06 January 2026

Re: As requested, comments on [REDACTED], Zwaanswyk

Figure 1 Elevation provided by original designer (not Ivory Plum)

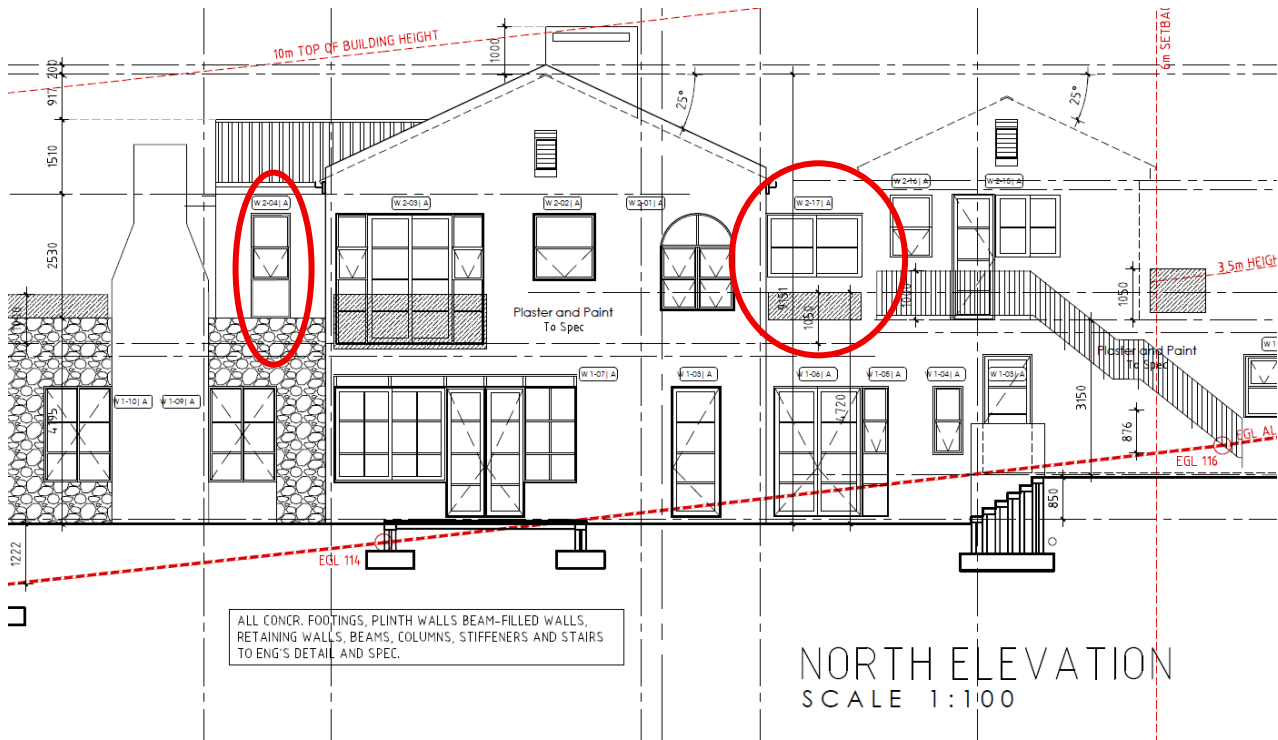
- Garden steps outside laundry: The arrow is pointing in the wrong direction. Staircase arrows point up the stairs.
- Roof plan does not show slab heights
- Guest W/C and Bedroom 5 internal walls: we would make 230mm thick to support slab height difference above, but Engineer could spec otherwise.
- Are all retaining walls spec'd by Engineer because we noticed they haven't been shown thick enough below ground level on the architectural drawings.?
- Elevation views are not showing all the walls. In some places, the elevation views are incorrectly showing windows. For example, Master Bedroom 1 outside shower showing a window not a sliding door. Master Bedroom 1 showing a window on the elevation where there is no window. There is a fireplace in that position.

- As a general rule, we allow 100mm around all internal doors for architraves.
- Staircase outside Bedroom 6 is very narrow for practicality.
- Our Note "A" on the Floor Plan shows a discrepancy of wall distance on the South Elevation, between the garage door and laundry sliding door.

Exterior

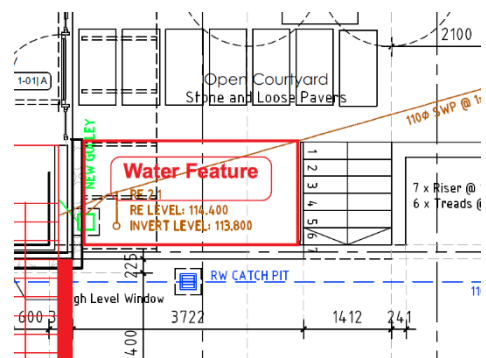
- Add garden gates to side of Garage and Bedroom 4. This will separate the driveway area from the back yard, practical if pets, etc.
- Add water feature on retaining wall outside front door.
- Gardeners Toilet with basin under (new) stairs to Bedroom 6 (from lower garden level).
- Open Courtyard: Add counter with prep bowl next to braai. Shift table to accommodate this.
- Pool needs an additional step from outside to Martini seat level. We propose an extra step for easy entry/exit from pool.

Garage

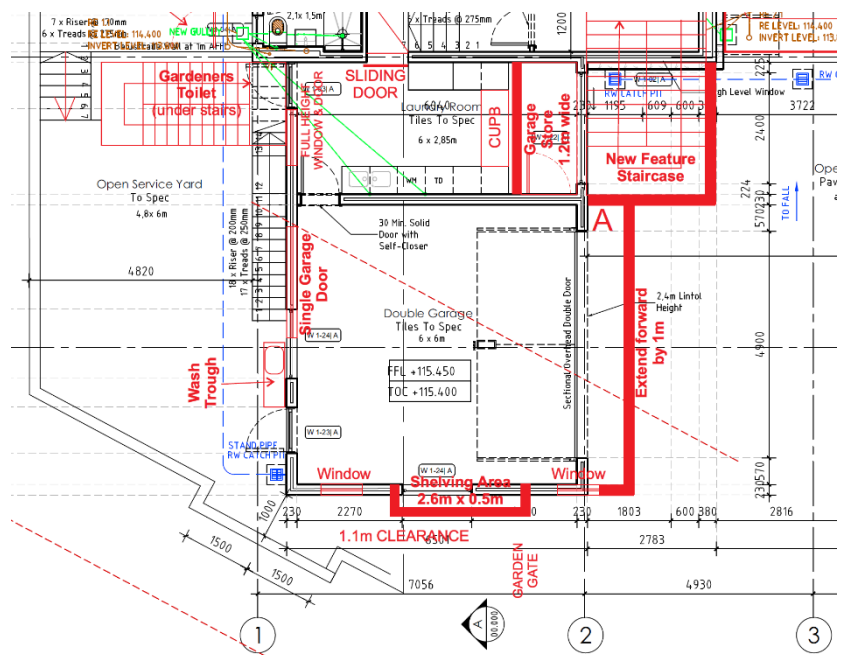
- Garage corner onto driveway boundary wall: It is important to ensure minimum of 1m is maintained during construction. 1m is already not practical for carrying larger items around, and could get smaller during initial building layout on site, so this should be checked.

- Garage size is 6m x 6m. This is the minimum size we would design for this spec of home, because it does not really allow comfortable space for larger cars and storage. The garage could be brought forward to increase the length, allowing for longer vehicles. This would also improve the building aesthetically since it would break the flat façade with the laundry.

- The garage door is a standard 4.9m wide. Might want to reconsider this with larger cars.
- See Note "A": Wall between garage door and laundry sliding door on Plan does not match South Elevation?

- Proposed Amendments:
 - Add Shelving Area: Step out on the West side of the garage with a cupboard niche. This adds unobstructive additional storage. The exterior can be clad with stone adding additional interest to the existing flat wall. Add windows to both sides of this area.

- Add single garage door to rear of garage. This allows for a drive-through for storage of trailers, bikes or other larger items in the Open Service Yard. This makes the Open Service Yard more usable and flexible. It still allows plenty of space for a washing line. Would require rotation of staircase to Bedroom 6 (See note on Bedroom 6). The window is replaced with the two windows either side of the new storage cupboard jut-out.

- Add counter and wash trough outside rear of garage (for washing of braai grids, shoes, bikes, etc.)
 - Shorten lengthy Laundry to add needed small Garage Store (household items, paint, tiles, also Tech Room)

Laundry

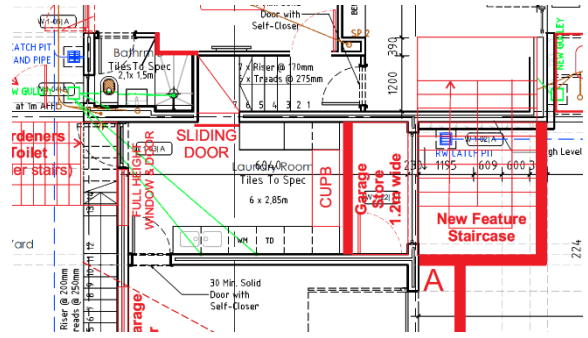
- Take some of laundry space to create Garage Store. Laundry cupboards will still be u-shaped and sufficient.
- To ensure proper laundry ventilation, we propose a full height wide opening window next to the swing stable door leading out onto the Open Service Yard.
- The laundry door will still be sheltered undercover provided by the repositioned Bedroom 6 staircase. Note: Gardeners toilet and small basin underneath staircase (access door from lower garden level for better height clearance)
- Would you need 2x WM and TD in the Laundry, because we noted WM and TD in the Scullery? Positioning of appliances correctly now affects placement of electrical and water points during construction.

Entrance Lobby/Visitor WC/Staircase

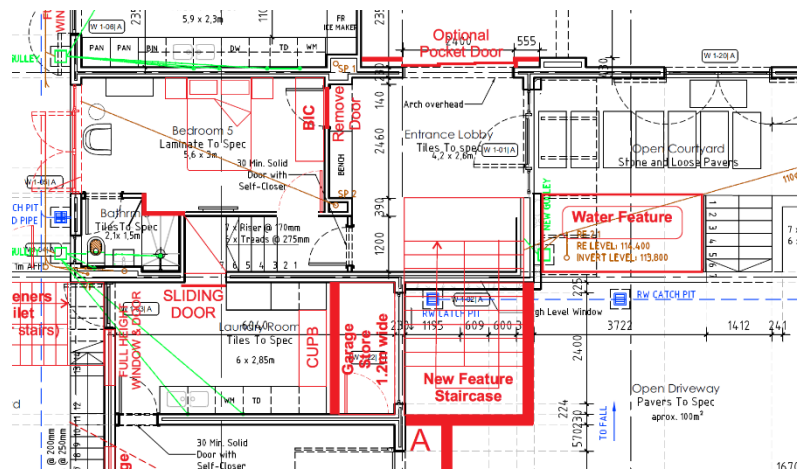
- Bedroom 5 entrance door to be moved out of sight from the Entrance Lobby. This provides the Entrance Lobby with an unbroken feature wall/bench design and gives better privacy to Bedroom 5. (See also Bedroom 5 note)
- Staircase is disjointed from the Entrance Lobby and at the far end of the house. It is far from the laundry, the front door and garage. Currently, it seems the staircase is not a feature, possibly cast in-situ? The wine store underneath looks like it will be more of a closet than a feature. Normally, in our designs, we make use of the opportunity to create a feature of the staircase.

- Swap staircase and visitor W/C. This allows for a “floating” feature staircase with feature corner window facing the driveway. It is better placed, more in the center of the house. This also reduces the passage length on the FF.
- FF landing of the proposed staircase will be a bridge, which allows for double volume space for a feature front door entrance. Double volume height means the front door can be a non-standard height to make a more impressive entrance to the home.
- OPTIONAL: Pocket sliding door into the Dining Room. This will provide some closure in winter for the Lounge fireplace to avoid heat loss. It will also create a visibly thicker arch into the Dining Area.

Guest WC

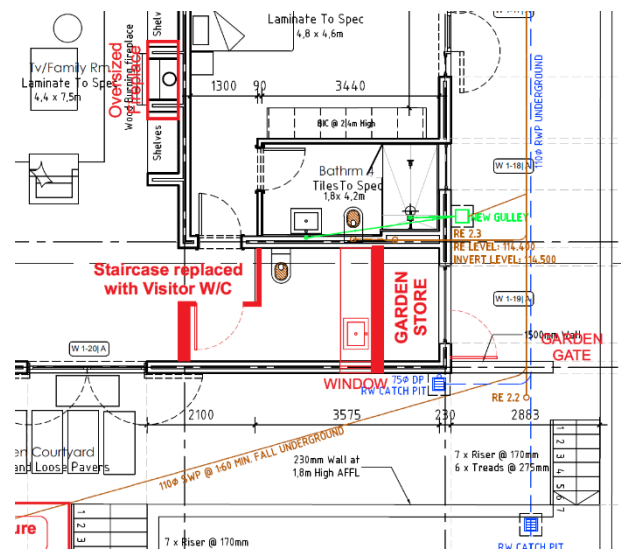
- Visitors toilet is proposed in place of the existing staircase so that it is practically off the open plan, yet still discreetly private with the door coming off from a screened lobby. We’ve still kept a long uninterrupted vanity with a prominent feature wall and placed a side window for ventilation while still ensuring privacy.
- In addition, in place of the existing stairs there is also a Garden Store accessible from the exterior. Useful for lawnmower, weedeater, etc. so that the gardener does not have to move past cars in the garage.

Bedroom 5

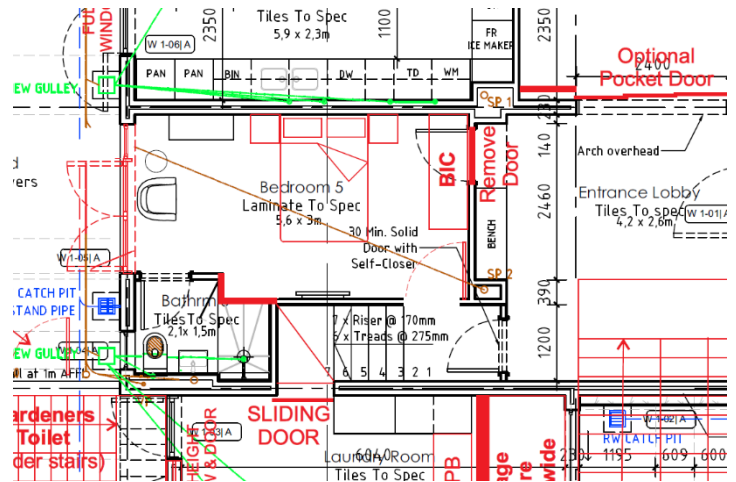
- It's not ideal to have this bedroom door directly off the Entrance Lobby, even if Bedroom 5 is a Study.
- Proposed Amendments:
 - Amend the steps to the laundry (with an additional winder) to allow Bedroom 5 door to be on the side next to the steps to the laundry. This change would allow for a better unbroken feature wall in the Entrance Lobby and gives better privacy to Bedroom 5.
 - Place BIC along length of room, not width.
 - OPTIONAL: Adjust the step in the shower wall to accommodate the bed in different position.
 - Swap the toilet and basin for better access into the shower.
 - Mirror exterior door/window to accommodate for more practical walking space.

TV/Family Room

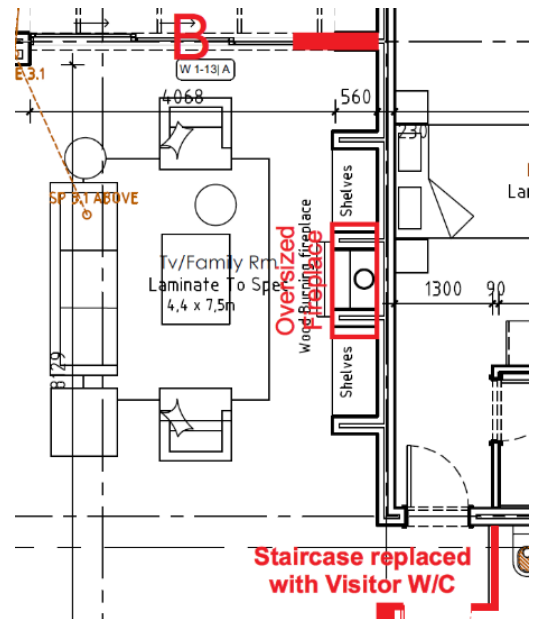
- Super-size the fireplace width and add thicker side nibs. It will look better aesthetically and also provide more heating for the open-plan.
- Are the additional side walls around the shelving (fireplace) required? It limits what you can do with cabinetry. It will look more modern without the side walls.
- Make the TV/Family Room door to the Covered Terrace the same size as the door from the Dining Room to the Covered Terrace (3.5m). It is important from the interior visual aspect that in the open space, these two sliding openings are the same in size. To do this, increase the length of the wall on the side of the fireplace, reducing the size of the TV Room slider. (On plan: B=B) Also take note of the open direction these sliding doors as it will impact on curtain stacking.
- Is there a plan for the TV position? Is it above the fireplace or next to it?

Sun Room

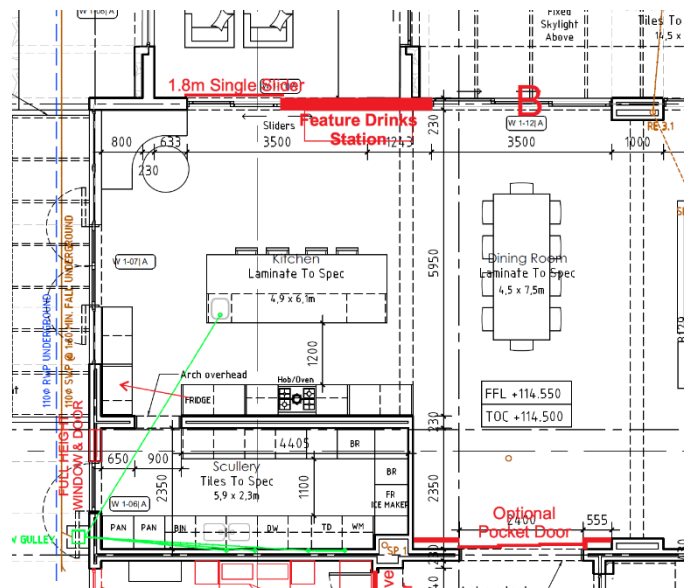
- Make the entrance to the Sun Room slightly narrower (still 1.8m wide). Use a large single sliding door. Possible use panelled glazing instead of a solid wood door.
- The distance between the fireplace and edge of the windows could be a hazard for window treatment (curtains, blinds). There should be more space between the fireplace and windows by making windows slightly smaller or moving them up.
- Is there a plan for TV position? Is it above the fireplace?

Pool Room

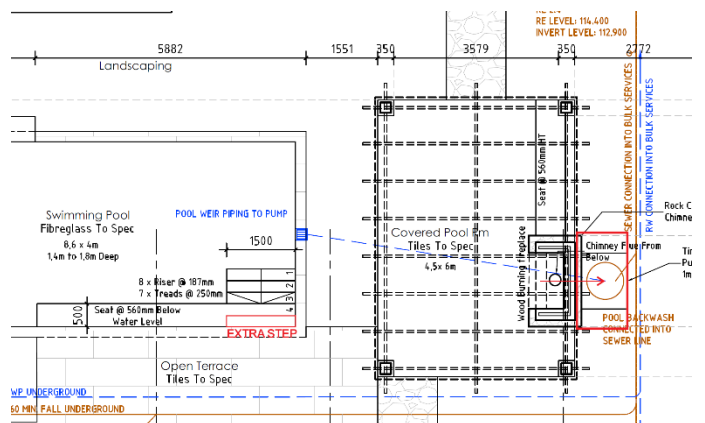
- Can the fireplace be placed on the outside of the floor area? This increases the usable floor area and makes furniture positioning unobstructed.
- There is no bar area, counter or prep bowl?
- There is no storage for sun lounge cushions, covers, pool equipment, etc? This could be stored in the Garden Store on shelves.
- An exterior Pool shower would be practical and a nice feature.

New FF Staircase Landing

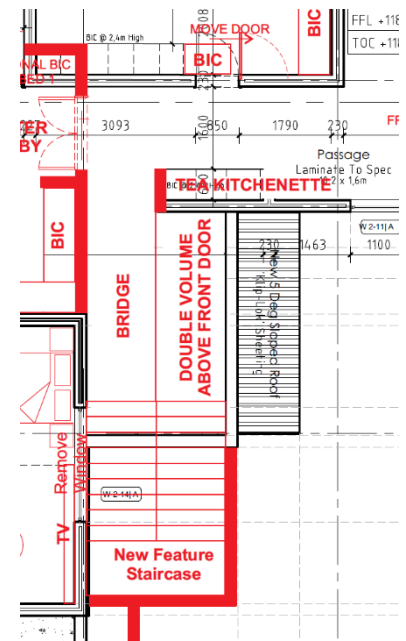
- The proposed new staircase has a bridge with balustrade on the FF. This allows the front door to have a double volume area, creating a welcoming and more grand entrance.
- The feature staircase treads can be “floating” and visible from the driveway (see top image with Entrance Lobby note).
- To incorporate the aesthetics of arched windows, the proposed corner arch window with butt-jointed glass detail is a focal entrance feature visible from the driveway (see lower image with Entrance Lobby note).
- A striking chandelier can be placed above the landing of the new staircase which would be noted on arrival.

PJ Lounge

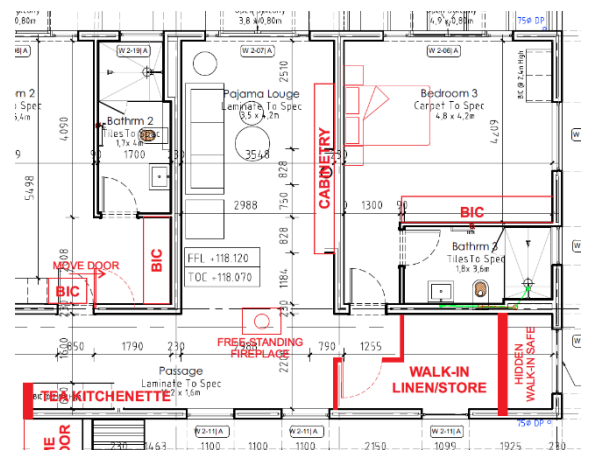
- The PJ Lounge is long and narrow. It can be widened by removing the fireplace from the width of the room and moving it to the length of the room.
- The kitchenette is moved out of the room.
- Proposed Amendments:
 - Tea Kitchenette moved out of PJ Lounge to the passage area. It will be larger and more practical than the existing coffee station, as well as use up some of the passage space. To include a small prep bowl and undercounter fridge.
 - Move the fireplace to be a free-standing “Morso” fireplace in the passage, thus it will still be a focal feature but give the room better special use. Use cabinetry for a narrower (but long) TV unit ensuring that the flue (from the Family/TV Lounge below) is bricked behind the cabinetry. The cabinetry will be narrower than brick walls, as well as more flexibility to be creative with cabinetry design. More space for TV on focal wall.

Master Bedroom 1

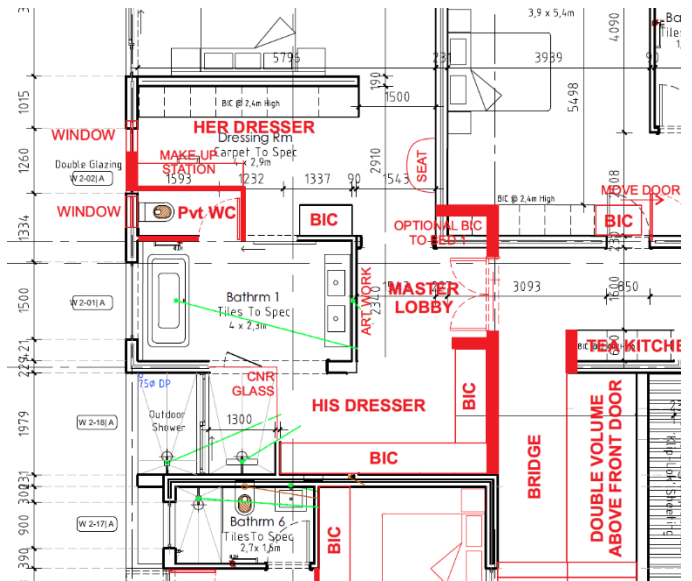
- Insufficient dressing cupboards for this standard of home.
- Proposed Amendments:
 - With the new staircase and bridge, entrance to the Master Bedroom 1 is moved to create a bedroom lobby for privacy.

- Take some space from the existing open roof slab to create "His Dresser." This adds approximately 5.2m of additional cupboards.
 - Move WC (900mm wide with window) next to the bath to allow for "His Dresser" to have access into the bathroom. This creates a walk-around "floating" vanity feature.

- Change enclosed shower to include corner glass next to "His Dresser" to create a beautiful feature and let natural light into "His Dresser."
 - Move ottoman seat to blank wall with full length mirror behind, thereby extending "Her" length of cupboard space.

- OPTIONAL: Take some space from Bedroom 2 for additional BIC in Master Bedroom 1 (since Bedroom 2 moved over and extra cupboards extended.)

Bedroom 3

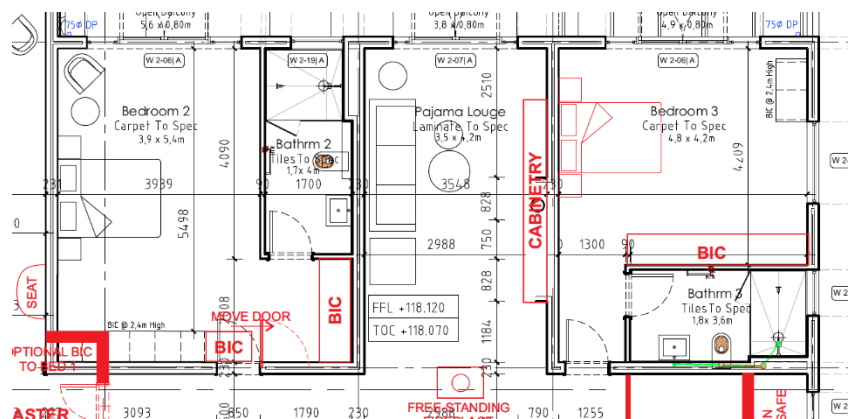
- There is a conflict with the BIC and bed pedestal.
- Not enough cupboard space.
- Proposed Amendments:
 - Rearrange bed layout to avoid conflict.
 - Allows for extended BIC's along bathroom wall, still keeping the cabinetry (BIC or desk) left of the East window.

Bedroom 6

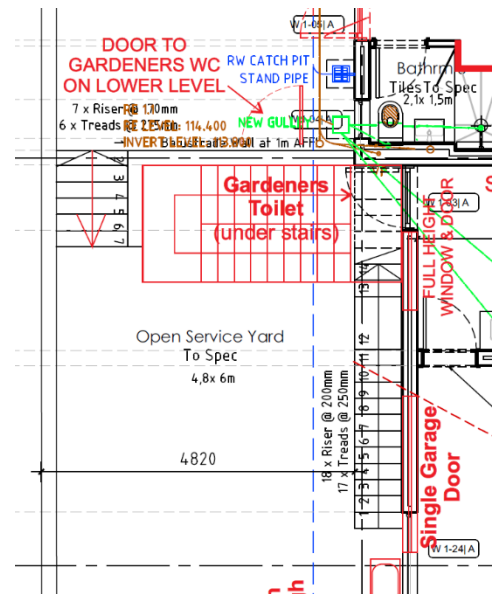
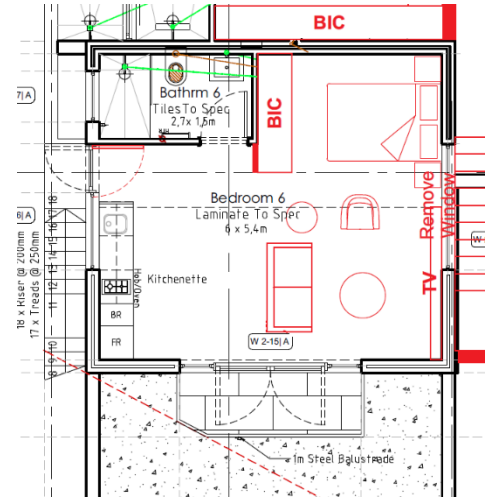
- External staircase too narrow. Existing staircase is only 730mm wide.
- Entrance door too narrow.
- Conflict with BIC and bed pedestal.
- Too little cupboard space.

- Proposed Amendments:
 - Proposed to rotate the staircase to cater for single garage door at rear of garage (gardeners toilet below, from lower garden level). New staircase 900mm wide. May allow for slightly shorter, more comfortable riser (to be calculated). Laundry door will still have cover from staircase.

- Rearrange sleeping area to East wall so that the bed pedestal and BIC's do not conflict. Allows for large BIC on bathroom wall. BIC now screens bed from entrance door.

- Rearrange lounge area furniture layout to still "separate" the sleeping and lounge areas. TV and desk on East wall (window removed).
 - Make entrance door standard 900mm, to swing inwards for better weather-proofing, safety and practicality.
